### **REMARKS**

### **Drawing Amendments**

Figures 5-7, 18, 19, and 21 have been amended to correct errors in the formal drawings previously submitted on November 28, 2001. Annotated drawings are enclosed herewith to show the changes made. In particular, Figure 5 has been amended to properly depict the frustoconical inner surfaces of the device. The amendments to Figure 5 are supported in the specification on page 5, lines 22-26. Figure 6 has also been amended to properly depict the frustoconical inner surfaces of the device, the amendments being supported in the specification on pages 5-6, lines 26-8. Figure 7 has also been amended to properly depict the cylindrical inner surface 18 of the device, the amendments being supported in the specification on page 6, lines 8-10.

FIG. 18

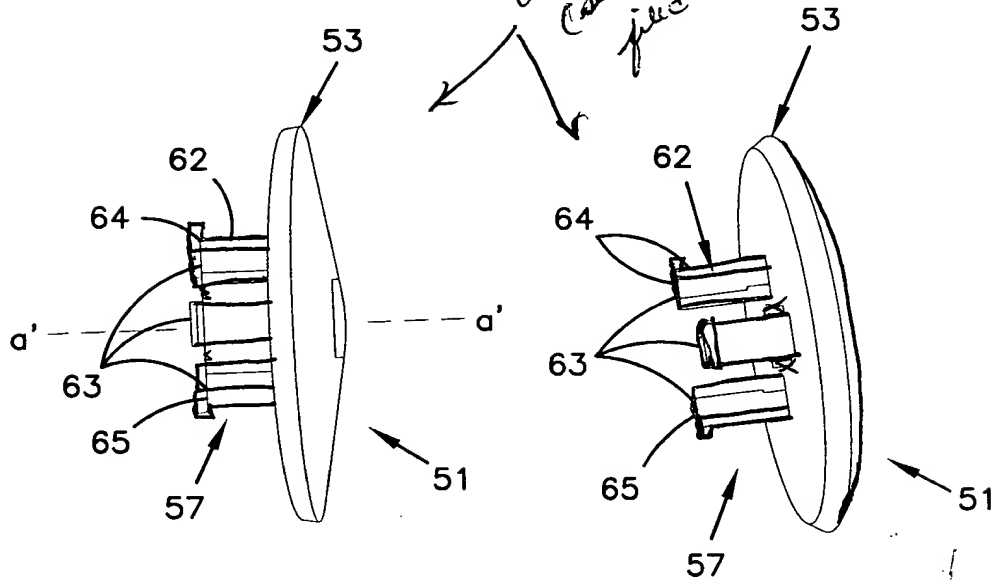
Figure 18 has been amended to properly depict the legs 63 of the locking element 51, as supported by the originally filed Figure 18. Figure 18 has further been amended to add a surface that should be shown in the perspective view. Figure 19 has been amended to clarify that the locking aperture 52 is formed on a surface that is partially shown (i.e. the outer circle should indicate that the surface extends beyond what is shown). Figure 21 has been amended to remove cross-hatching shown in the grooves 61 illustrated in the locking aperture 52.
